**Re: 704 Washington Street
Site Plan Peer Review**

- Plans (13 sheets) entitled: **Site Plan Amego Inc. 704 Washington Street**; dated July 19, 2022, revised through February 9, 2023; prepared by Level Design Group, LLC. Inclusive of the following:

DATE: February 15, 2023
TO: Franklin Planning Board
FROM: Department of Planning and Community Development
RE: 704 Washington Street
Site Plan

Level Design Group, LLC (LDG), on behalf of Amego, Inc., hereby submits the attached documentation for response to comments from Beta Group, Inc. of January 19, 2023. The comments and responses follow the same format as the letter dated January 4, 2023.

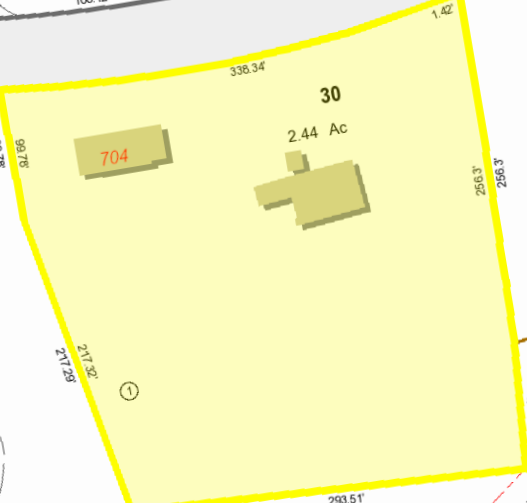
1. Planning Board requested less tree clearing along the back of the property. *Applicant has provided*
2. Planning Board requested the abutting structures be shown on the plan. *I have provided a map of our GIS showing abutting structures.*
